# SERVICE BULLETIN

NO. 840A

Date: November 7, 2013

**FUEL SELECTOR VALVE COVER REPLACEMENT**

**Figure 1**

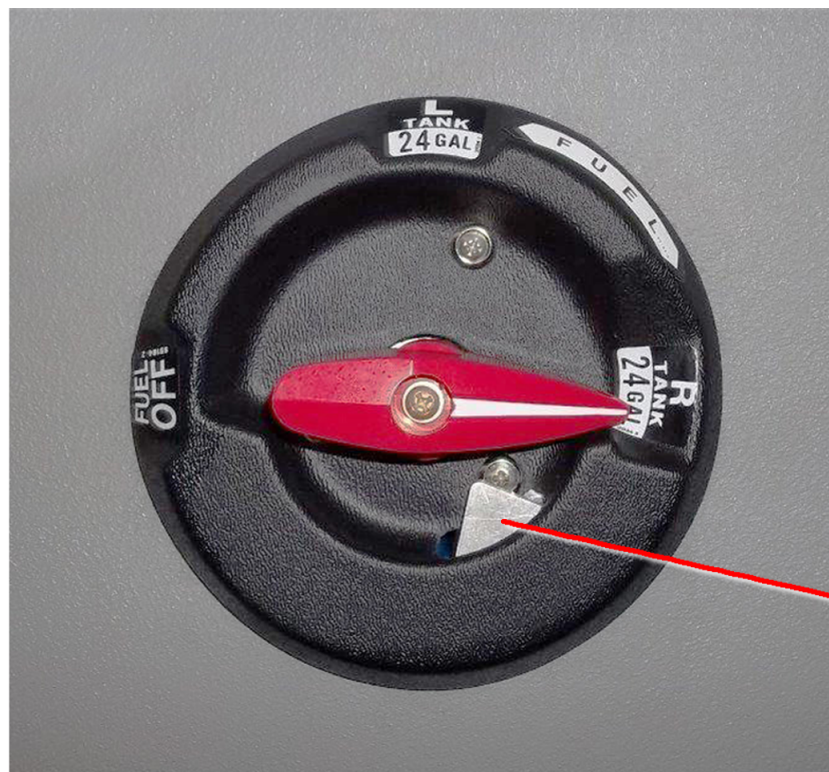
To announce the availability of a new fuel selector valve cover assembly and mating handle, which reduces the possibility of pilot mismanagement of the fuel system through inadvertent selection to the "OFF" position, resulting in power interruption or stoppage.

**NOTE:** Figure 1 shows the replacement fuel valve cover properly installed.

**NOTE:** Figure 1 shows the replacement fuel valve cover properly installed.

**NOTE:** Figure 1 shows proper installation of Piper Part Numbers 760-545 and 760-546. P/N 760-545 is similar to 760-546, except 760-545 includes additional parts and instructions to accommodate an adjacent cabin air vent (cabin air vent not shown in Figure 1).

All instructions necessary to accomplish this modification are contained in Piper Kit No. 760-545, Fuel Selector Valve Cover Replacement.

One (1) each Fuel Selector Valve Cover Replacement Kit, Piper P/N 760-545, per aircraft; one (1) each Air Vent Flange Kit, Piper P/N 65735-219, color black, per aircraft.

All instructions necessary to accomplish this modification are contained in Piper Kit No. 760-546, Fuel Selector Valve Cover Replacement.

One (1) each Fuel Selector Valve Cover Replacement Kit, Piper P/N 760-546, per aircraft.
